[MB¹] US NB comments on ISO/IEC 1st WD 27033-1³

Date: 2007-MM-DD	Document: SC 27 N5908
------------------	------------------------------

Attachment 1 for SC27N5908 Document

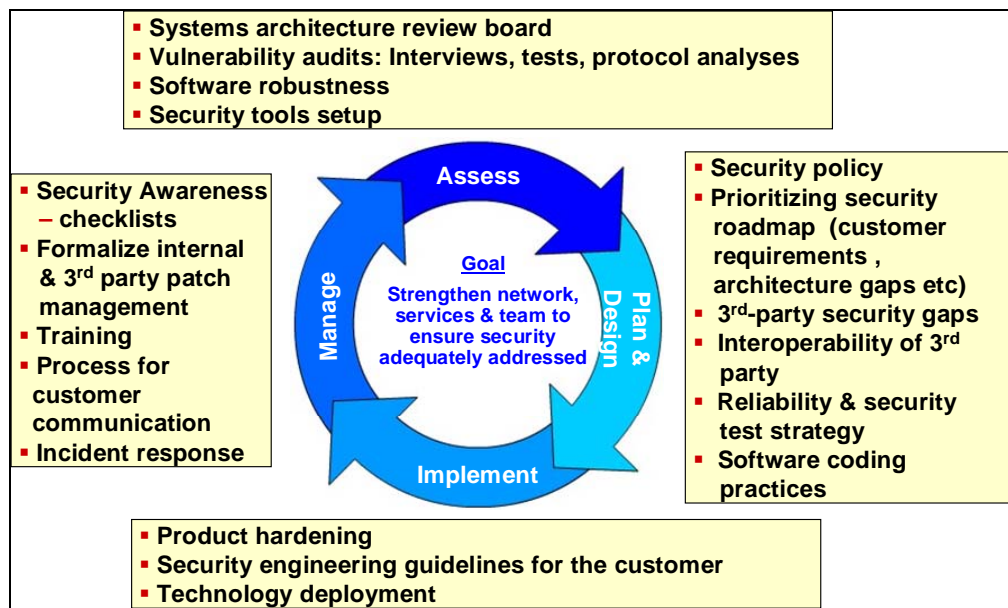
[US] 3	ALL		GE	Currently Part 1 seems to be addressing too many aspects in varying levels of depth. The previous comments have suggested that the content for Part 1 be an over-arching document for the series. However, it appears that the draft is also proposing some other aspects (such as incident management, monitoring etc.) – which obviously is not well integrated into the overall flow.	Depending on the resolution of the first 2 US comments, we also offer another perspective for organizing the content of Part1 using the PDCA model (see Attachment 1). The attachment shows the approach for managing

The PDCA model can be utilized to organize Part 1 to provide a context to the various sections which currently do not flow well in the draft. The content here is taken from existing ISMS documents and is primarily to illustrate a possible layout for Part 1 (Guidance on Network Security) which changes as appropriate.
